*Design Review Board
May 4, 2016*

MINUTES OF A REGULAR MEETING OF THE DESIGN REVIEW BOARD OF THE TOWN OF CLARKDALE HELD ON WEDNESDAY, MAY 4, 2016, AT 6:30 P.M. IN THE MEN’S LOUNGE OF THE CLARK MEMORIAL CLUBHOUSE, 19 N. NINTH STREET, CLARKDALE, AZ.

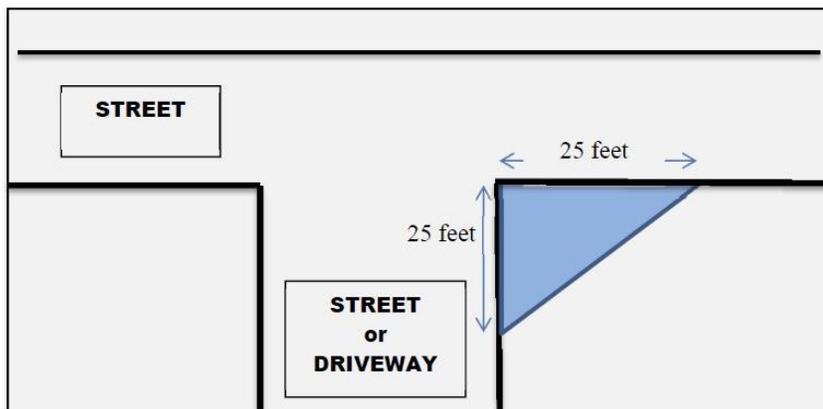
Zoning Code Chapter 7, Section 7-8 Permitted Signs. D. Off-Premise Commercial Signs:

- 1. Maximum number equals one per street frontage per parcel on which the sign is placed. Proof provided to the Town of permission from the parcel owner is required prior to installation of any off-premise sign.***

- 2. Maximum size of sign advertising a single use equals 32 square feet.*** The proposed off-premise sign is 12 square feet. Application complies.
- 3. Maximum size of sign advertising multiple uses equals 50 square feet.*** No multiple uses are proposed. Application complies.

- 4. Minimum separation between off-premise signs equals 600 feet, includes signs on same or different parcels.*** The distance between the two signs is 327 feet. Application complies.

- 5. Minimum separation between off-premise and on-site signage equals 200 feet.*** The distance between the two signs is 327 feet. Application complies.
